SUBJECT: Forwards responses to NRC 880121 questions re application to use low enriched U fuel.

WORCESTER
POLYTECHNIC
INSTITUTE

Enclosed please find the responses to the questions submitted on January 21, 1988, as a result of our application to use low enriched uranium fuel.

Attachment 2 HEU to LEU Conversion

Figure
TEMPERATURE COEFFICIENT

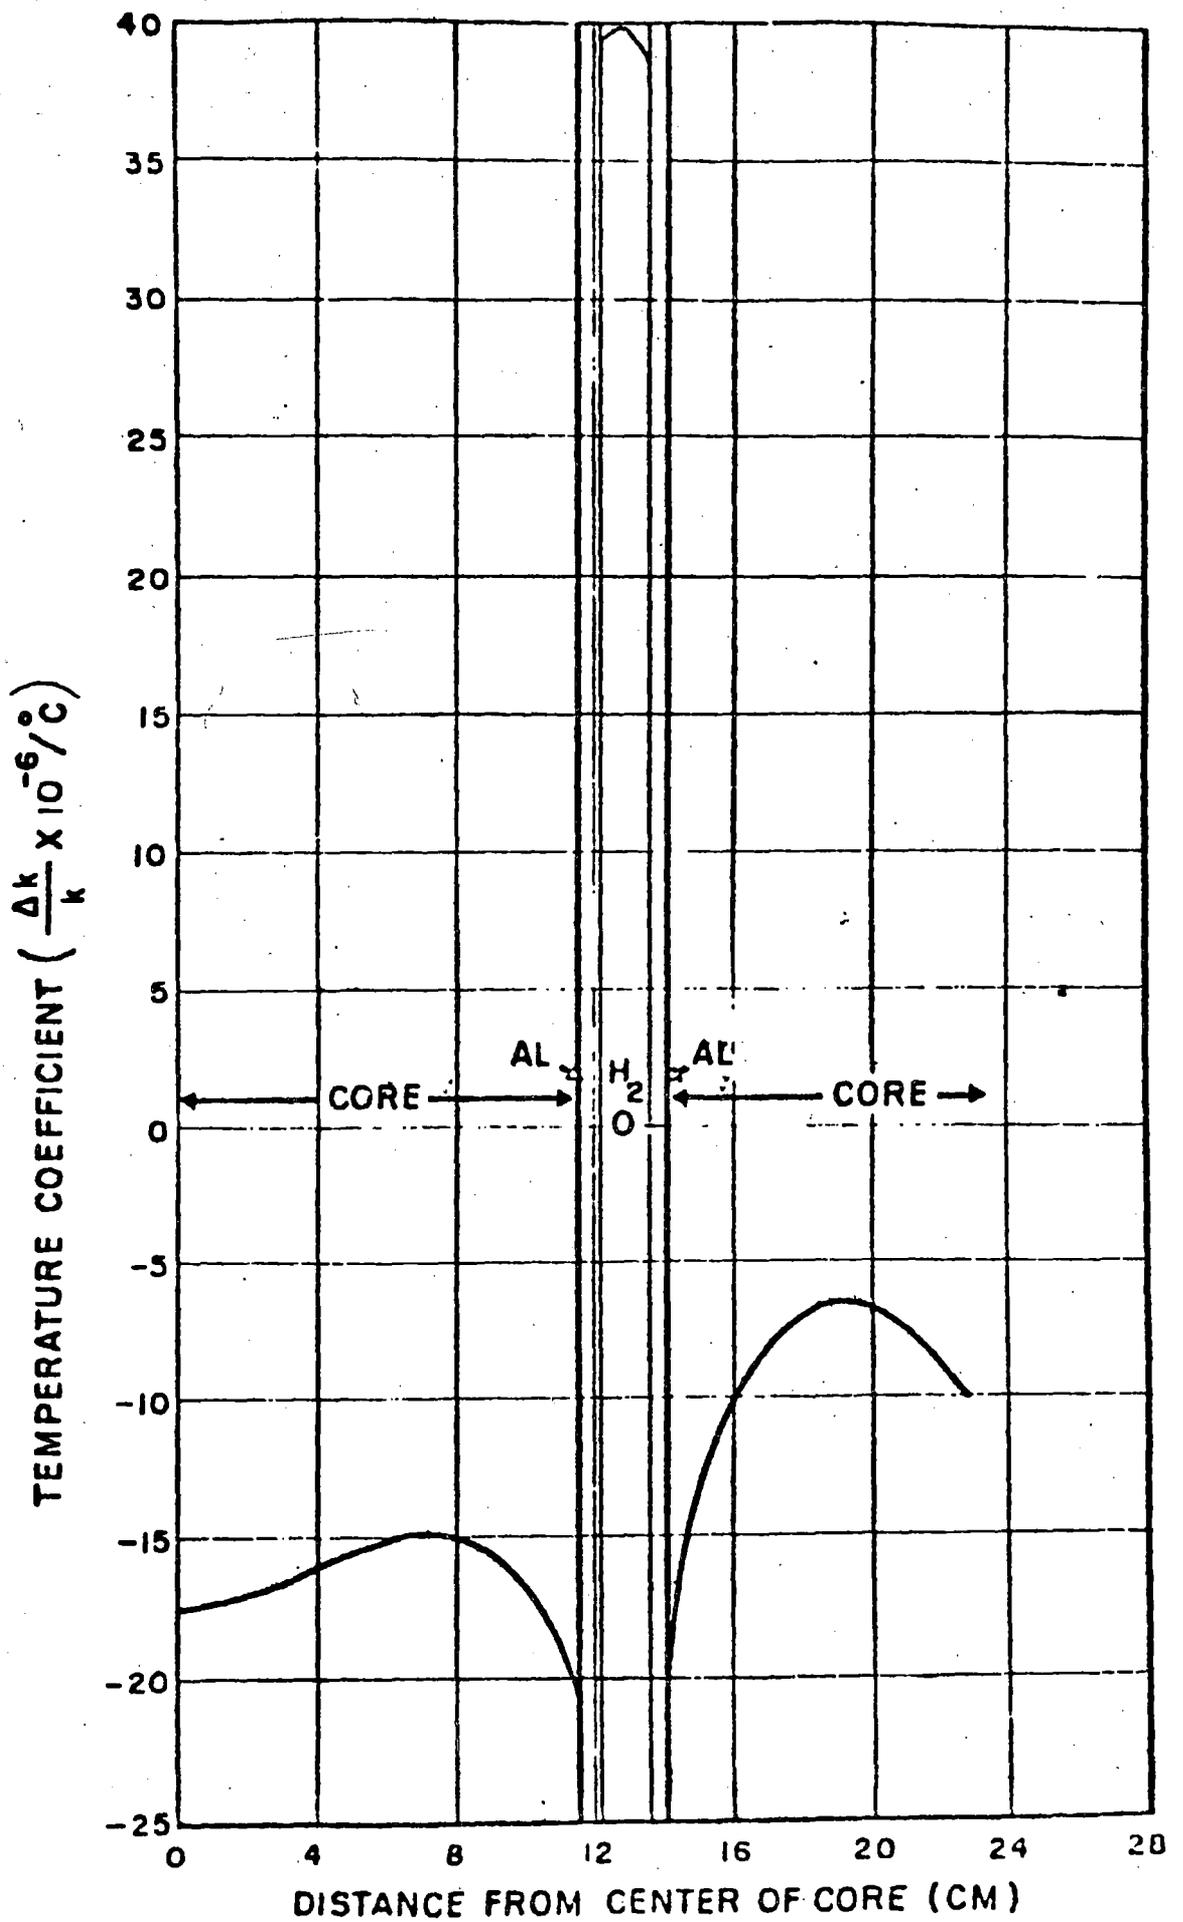
3. In any power excursion, water surrounding the fuel will be heated to a higher temperature (and lower density). Since temperature and void coefficients are more negative in the fuel regions than in the non-fueled regions, such as shown in Figures 9 and 10 from our current SAR, enclosed, any reactivity changes due to temperature and density changes in the fuel regions would be more negative in an excursion than the stated reactivity coefficients would imply, since they are based on an average change throughout the core region, as is discussed in Section 5.7 of the ANL report.
